Name Of Dam: MITCHELLS
Location: PATRICK COUNTY
Inventory Number: VA 14109

PHASE I INSPECTION REPORT NATIONAL DAM SAFETY PROGRAM

MAY 1981

PLAN VIEW

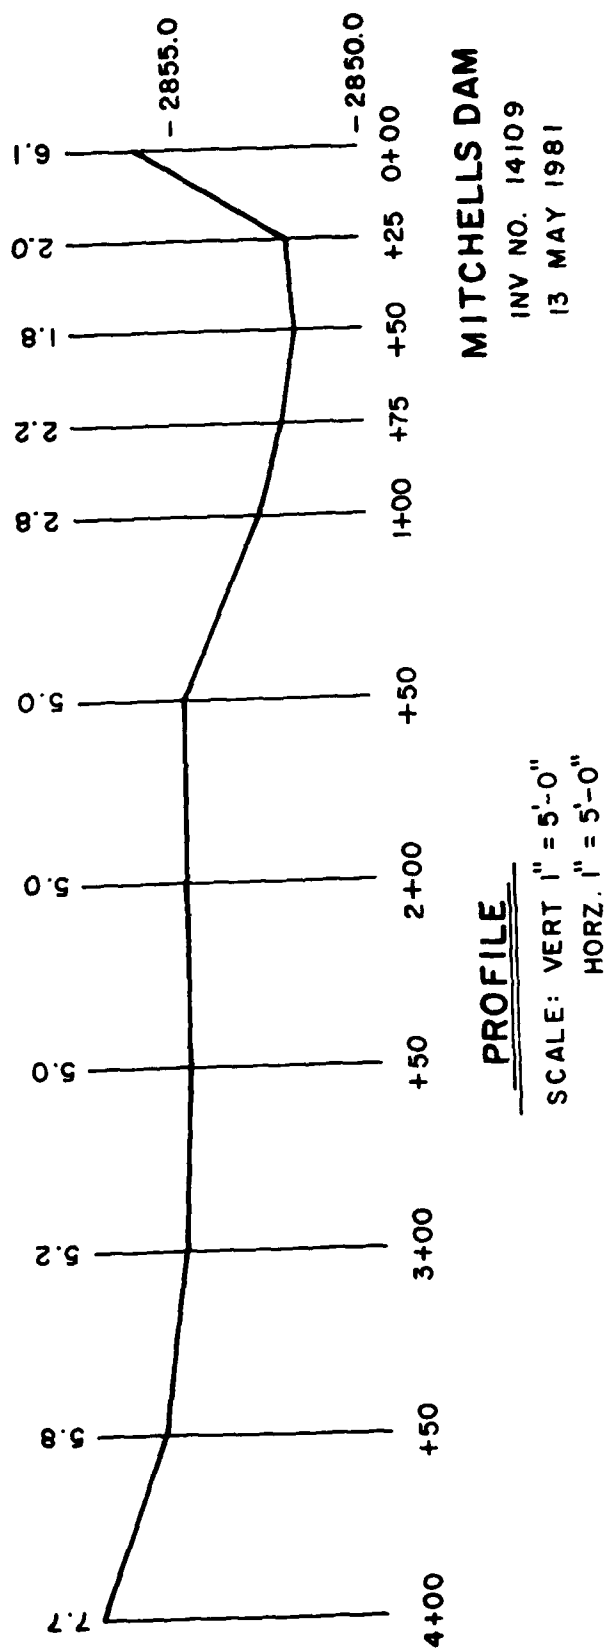
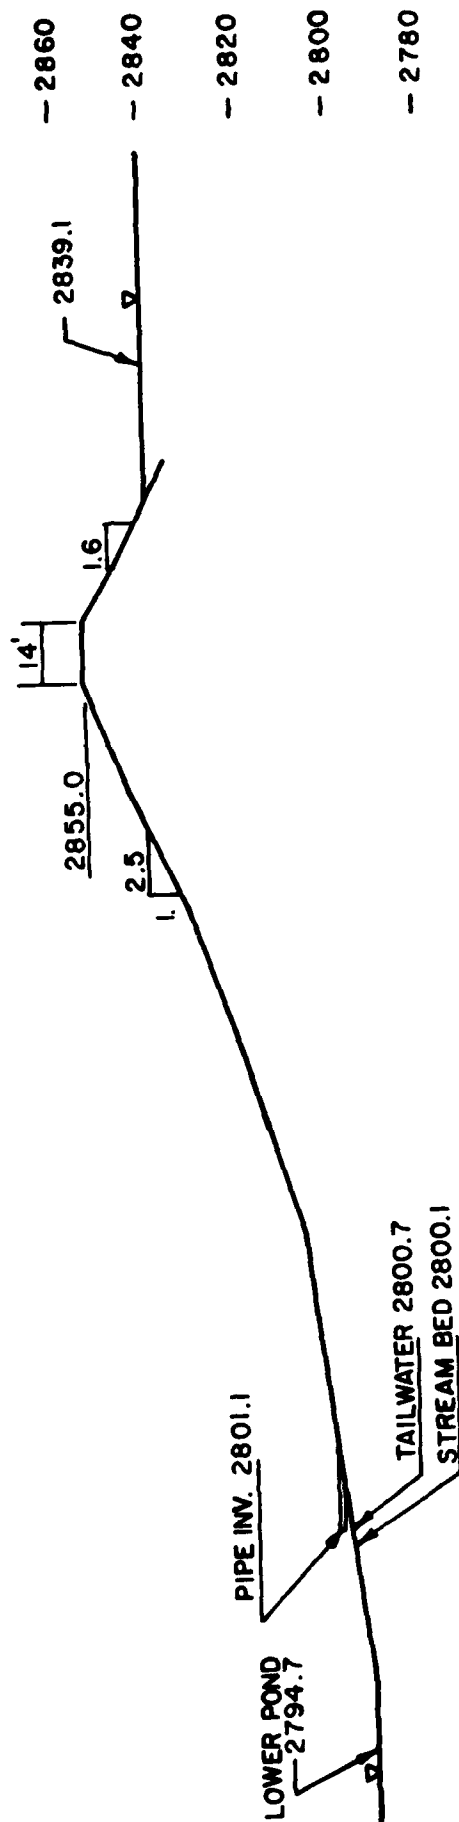
3.1.1. General: The field inspection was conducted on 13 May 1981. The weather was sunny and dry with temperatures in the low seventies. Ground surface conditions along the embankment were moist. At the time of the inspection the pool elevation was at 2839.1 ft. msl which is approximately eleven feet below the normal pool elevation of 2850.0. Overall the dam appears in good condition. However, several deficiencies were observed necessitating remedial treatment. A field sketch of the conditions observed during the inspection is located in Appendix I.
